DATE: 10/13/2020	PROJECT NO.: 2986
ATTENTION:	
RE: Windsor Forest Knolls	
Lot 4 Revised Perc Cert and OSDS Plan

PROJECT: WINDSOR FOREST KNOLLS
LOT 4

TITLE: REVISED
PERCOLATION CERTIFICATION PLAN

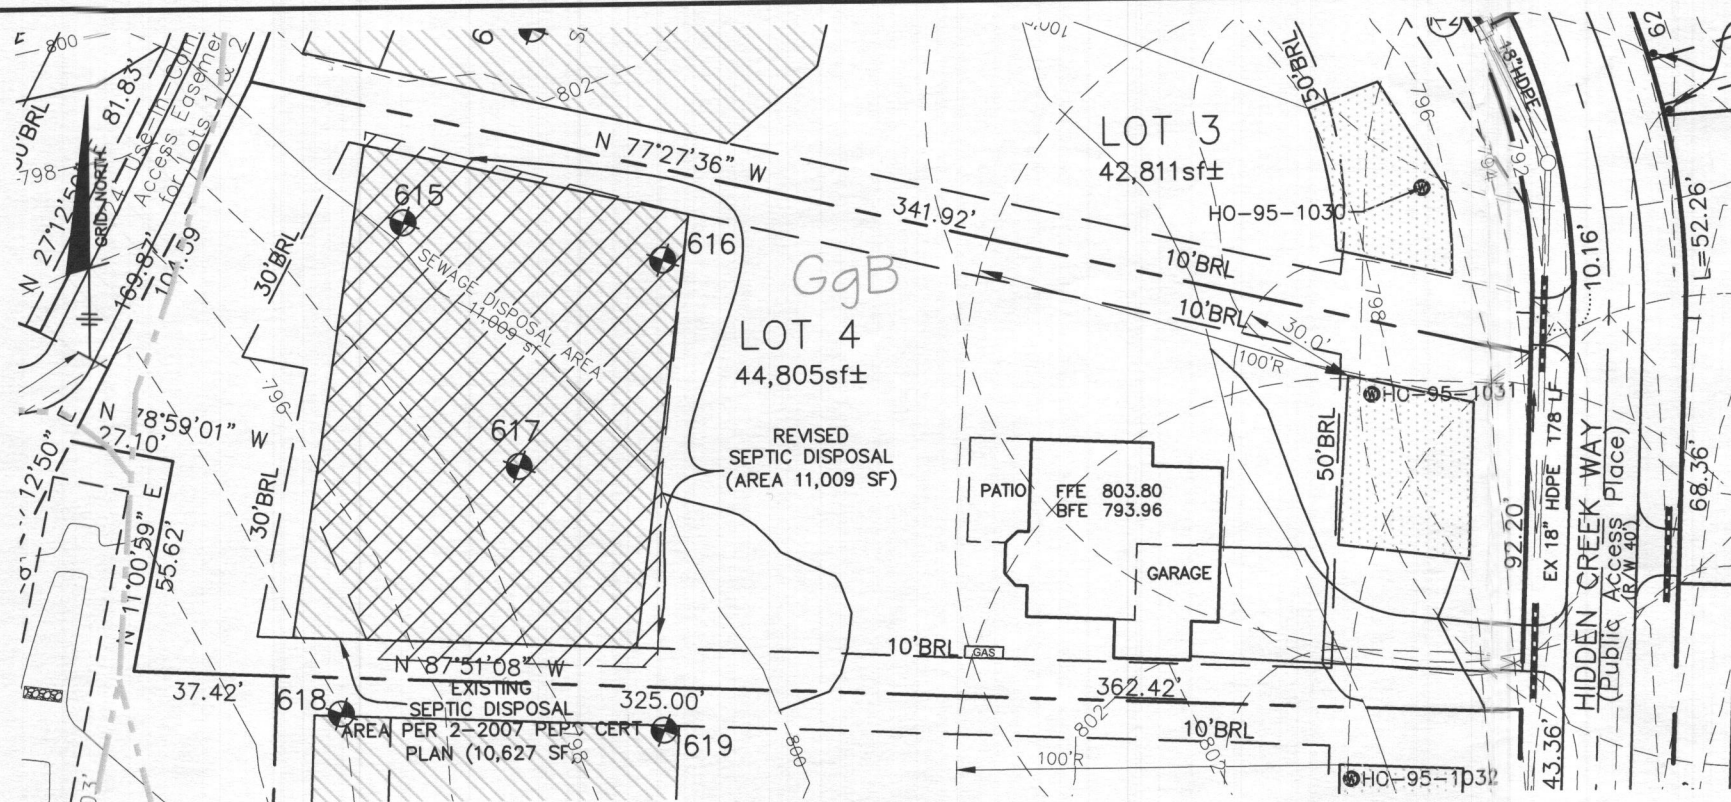
I don't think we can head down the hill towards a swale past the passing test holes here. Maybe shift everything up the hill and add area above the top holes

The attached is only a perc certification proposal. This lot is sold as a 4 bedroom, and I couldn't find a reasonable proposal for 5 bedrooms, so I'll design it as it is sold. But the variable grades make a layout very tricky. See if you are okay with this proposal.

That looks fine

Jeff - see if this is more acceptable.
